# TPS Transport Consultants Ltd

## Road Safety Audit Response Report

Client	Avant Homes
Project	Barugh Green Road, Barnsley
TPS Reference	P2636
Date Prepared	04.09.25
Prepared By	JT
Checked By	JA

**Road Safety Audit Stage 1**

## Revised Access Arrangements

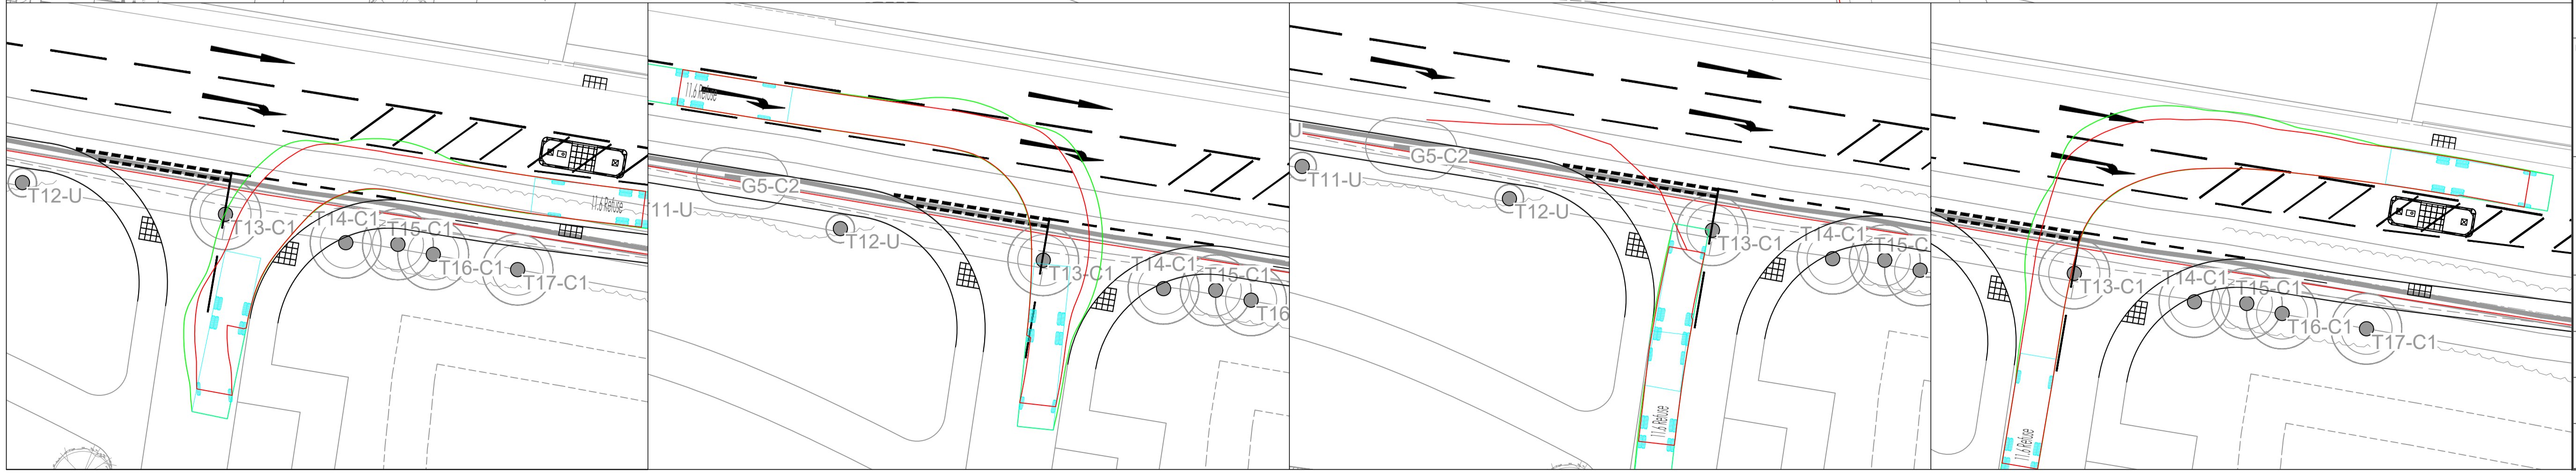
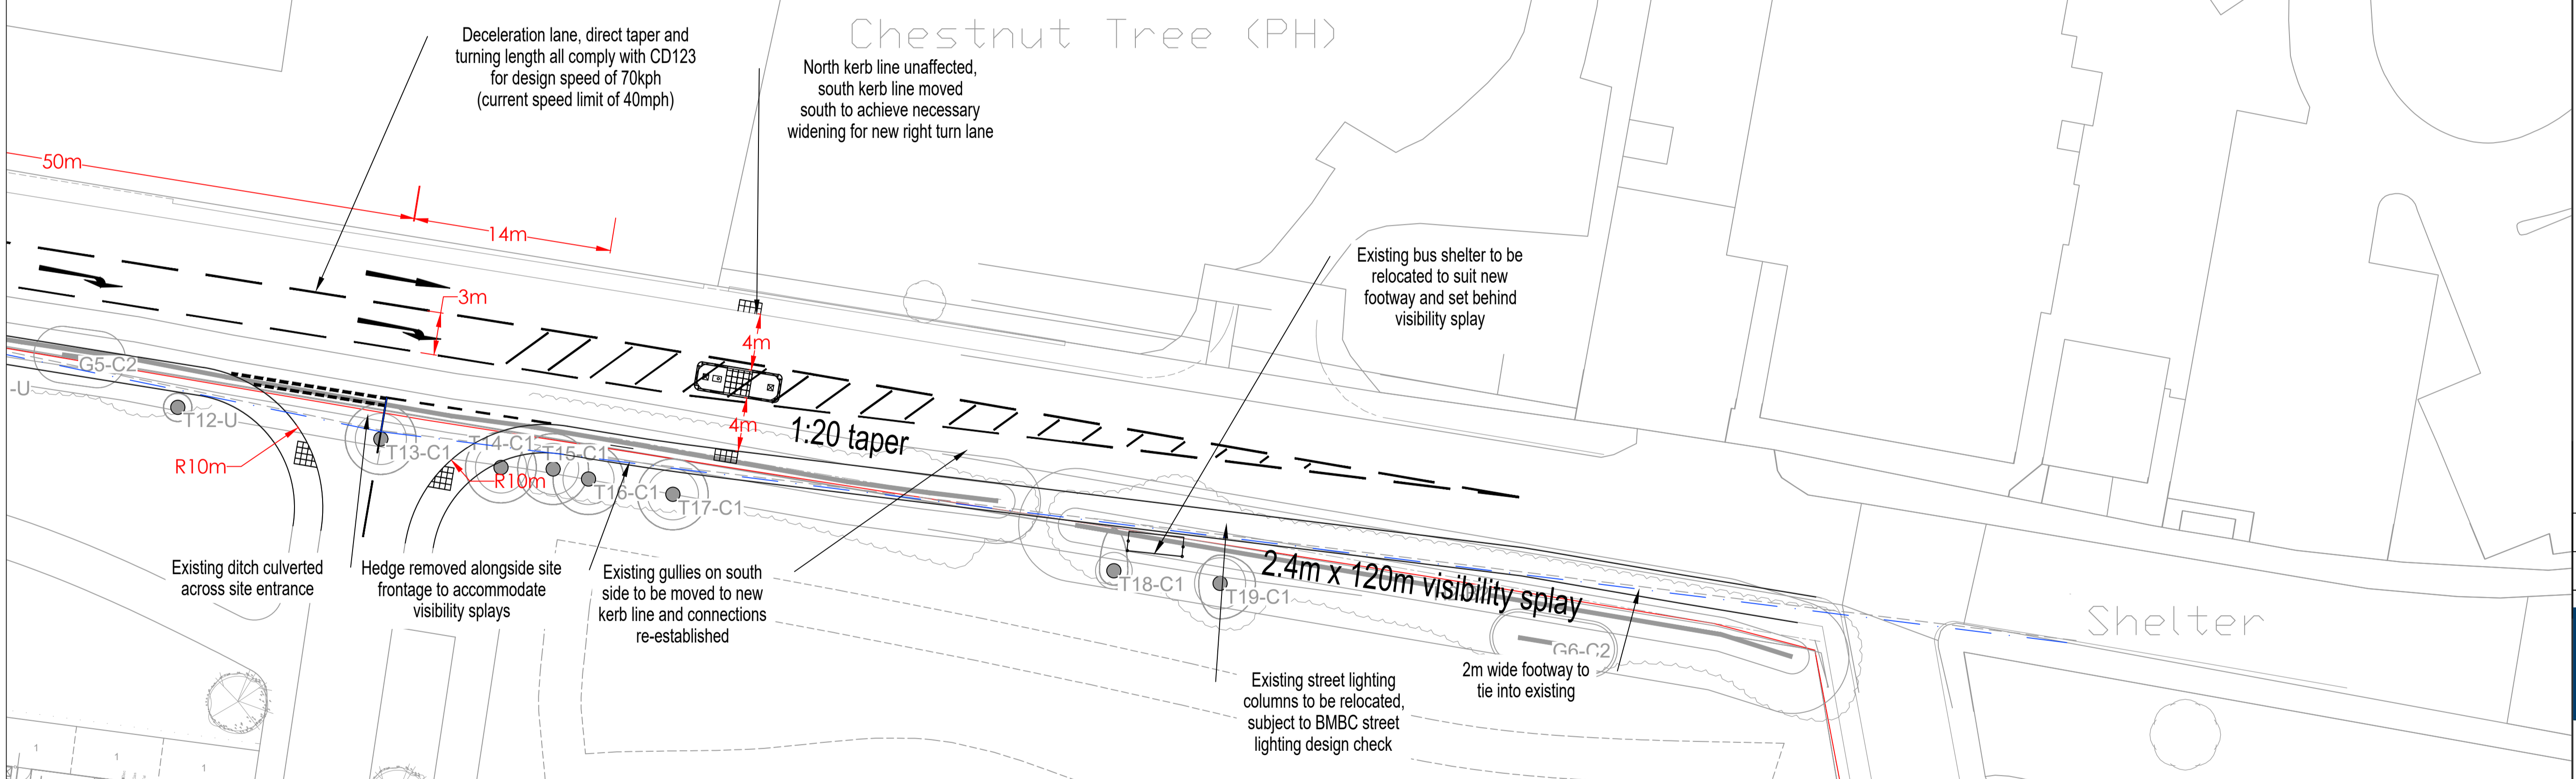
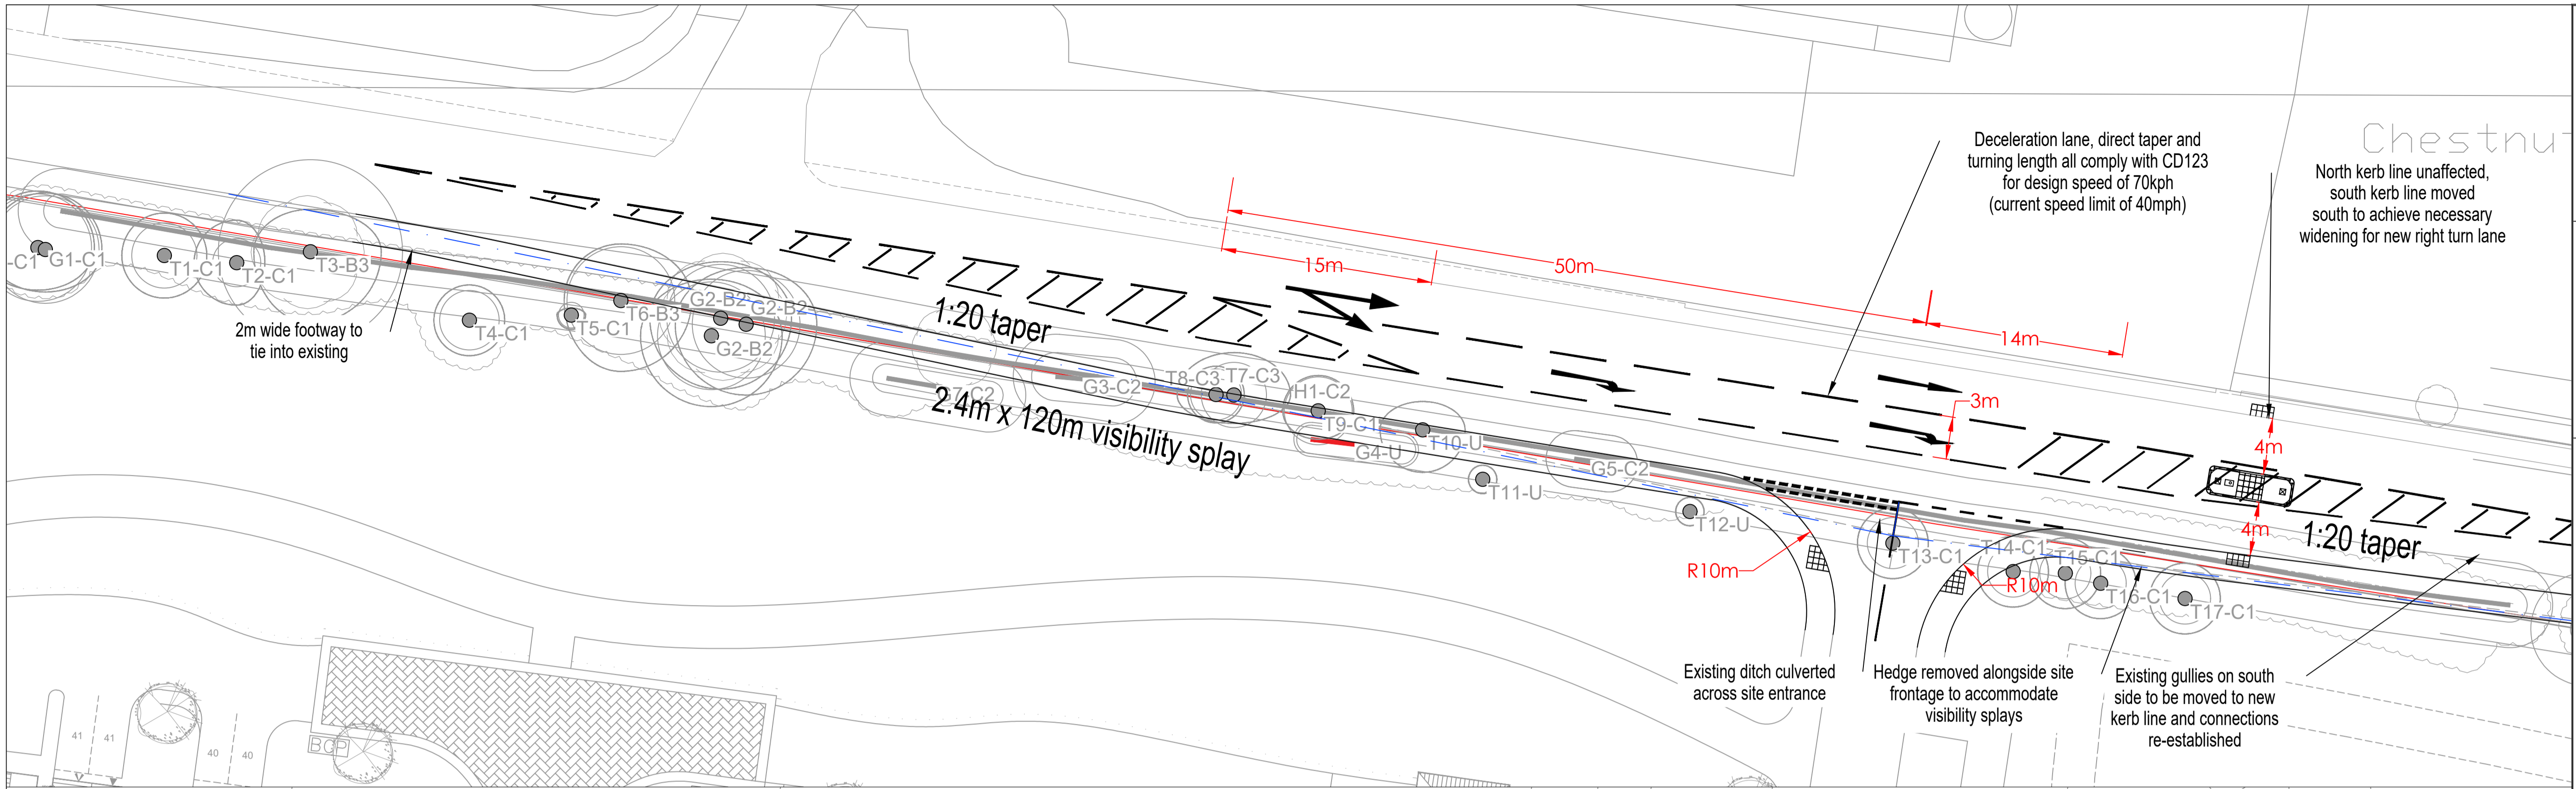
<p>A-05 - Barugh Green Road – At the proposed crossing.</p> <p>Pedestrians – Lack of footway space at the dropped crossing may increase the risk of pedestrians and other active modes being involved in a collision on the main carriageway.</p> <p>The footway along the northern side of Barugh Green Road is narrower than what would be considered desirable. This is exacerbated by a kerbed feature to the back of the footway. This may increase the risk of congestion around the dropped crossing point and make manoeuvring mobility scooters and wheelchairs</p>	<p>It is recommended that the proposed pedestrian refuge is relocated marginally east to the supermarket pedestrian access where there is additional space at the back of the footway. It is also recommended that negotiations are entered into to establish if widening of the footway behind the highway boundary can be provided.</p>	<p>Agreed.</p> <p>The drawing attached at <b>Appendix C</b> demonstrates the revised location of the proposed crossing facility to the location suggested by the audit team.</p>

It is recommended that the proposed pedestrian refuge is relocated marginally east to the supermarket pedestrian access where there is additional space at the back of the footway. It is also recommended that negotiations are entered into to establish if widening of the footway behind the highway boundary can be provided.

Date	Rev	Description	Drawn	Check
04.08.25	C	Amended in line with recommendations from Stage 1 RSA	JA	JT
17.12.24	A	Site layout plan updated to final layout	JA	JT
